# UNITED STATES PATENT AND TRADEMARK OFFICE

APPLICATION NO.	FILING DATE	FIRST NAMED INVENTOR	ATTORNEY DOCKET NO.	CONFIRMATION NO.
10/003,308	12/06/2001	Solgun Drevik	112057	4803

## Office Action Summary

FIG. 1

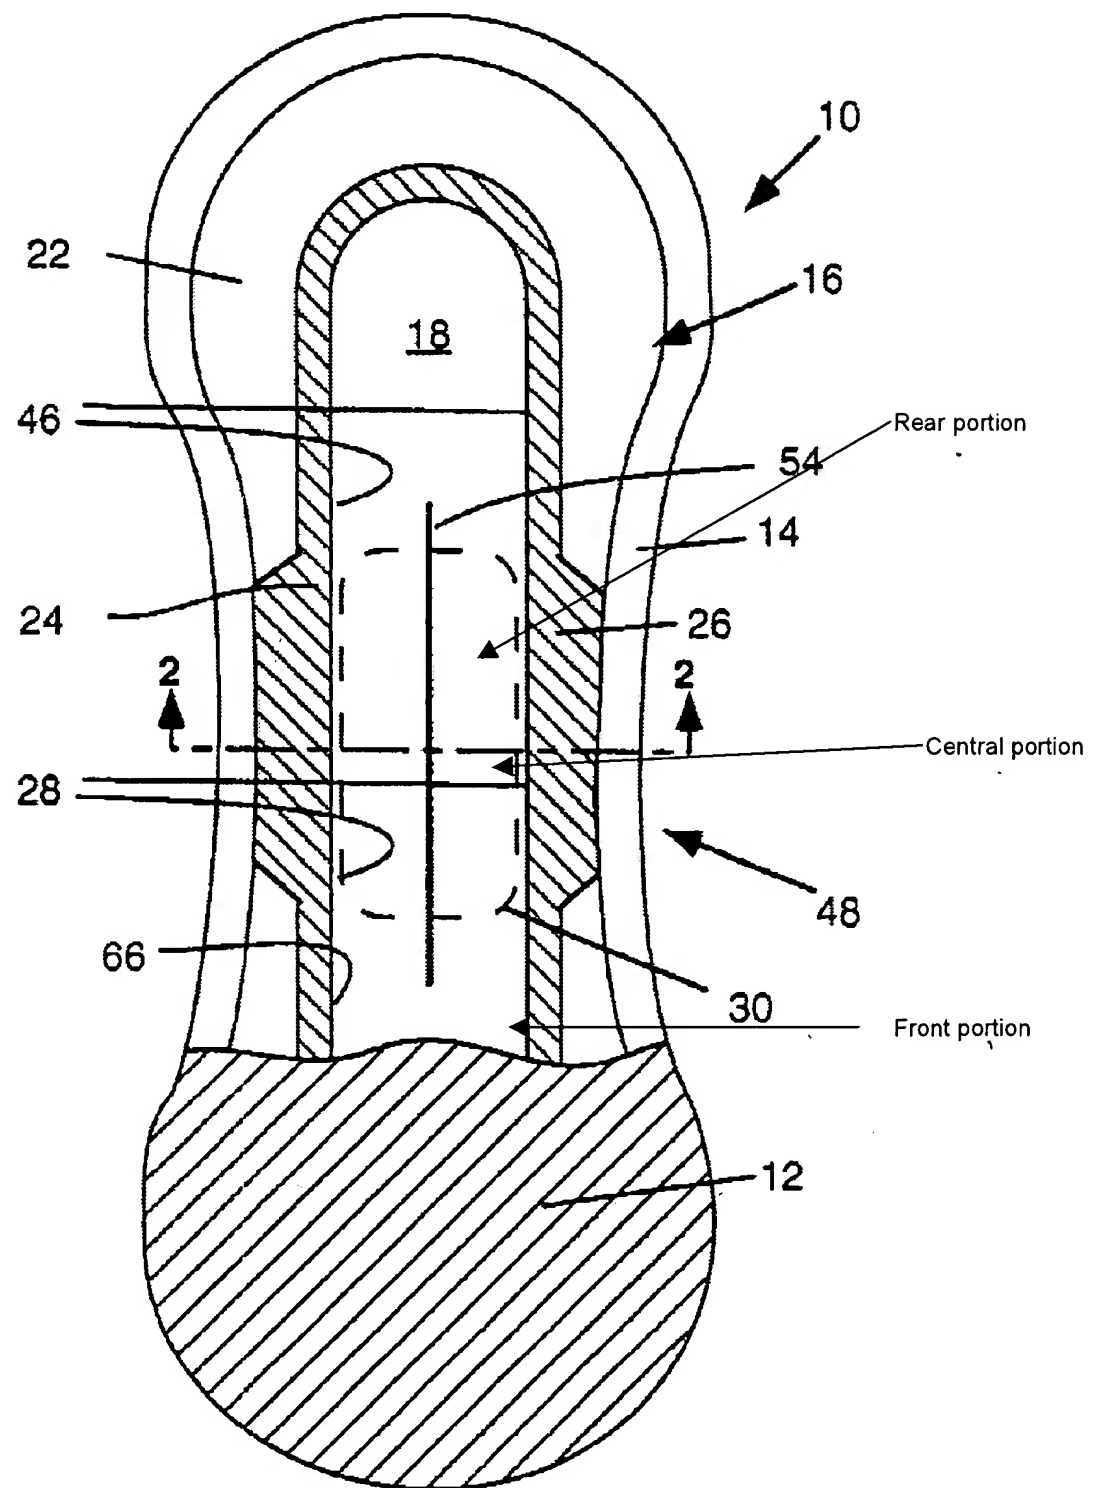
In response to the applicant's arguments that Chen does not disclose a split rear portion, the examiner refers to figure 1 as shown below.

Figure 1 shows what is considered as the front, central and rear portions. The elastic member (30) extends through all of these regions as does element (54) designating the split portion in these regions (see figures 1, 6 and 9). Therefore, Chen does provide the layer (18) split into two legs (in the area represented by 54) in a rear portion.
